GMS Composite Ltd.

Shardagonj, Kashimpur, Gazipur, Bangladesh
(23.968661, 90.296963)

22 March 2014

Observations

Typical Column Layout – Building 1

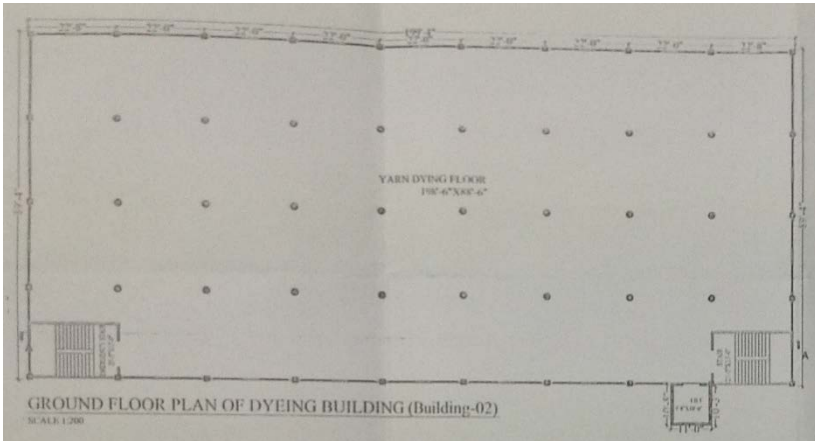
Cursory calculations indicate that the working stresses of columns are at a high level.

Building Engineer to check that columns have been designed to accommodate applied loads.

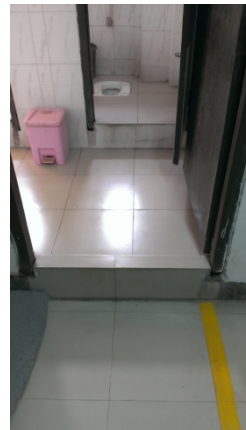
Water tanks with concrete bases located at roof level (Building 1) supported on regular slab and beam structure spanning between columns.

Increased floor build-up in toilet block areas (~160 + 110mm in cubicles).

Additional approx. 100mm thick concrete ceiling above toilet blocks.

Storage added on top of ceiling slabs in a number of areas.

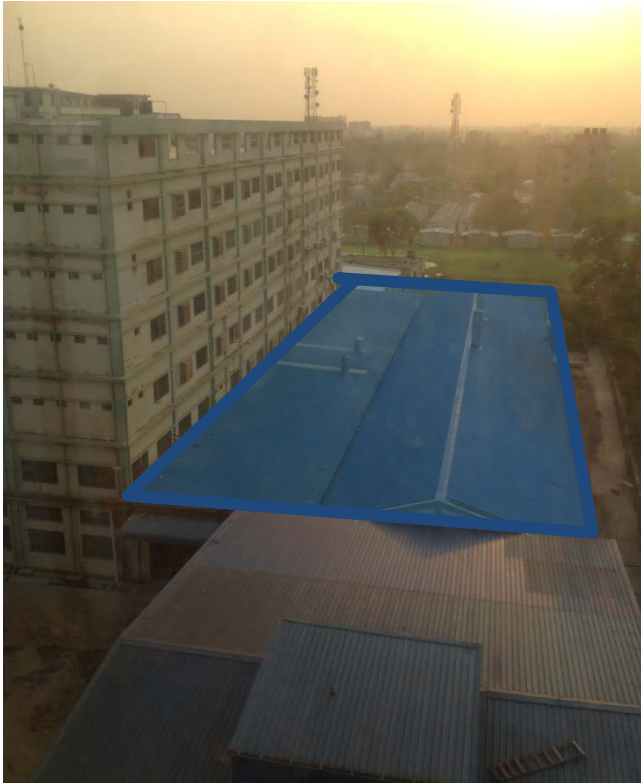
No structural or design documentation provided for horizontal extensions.

Building engineer to carry out detailed engineering assessment of extensions and impact of additional loading on the primary building structures.
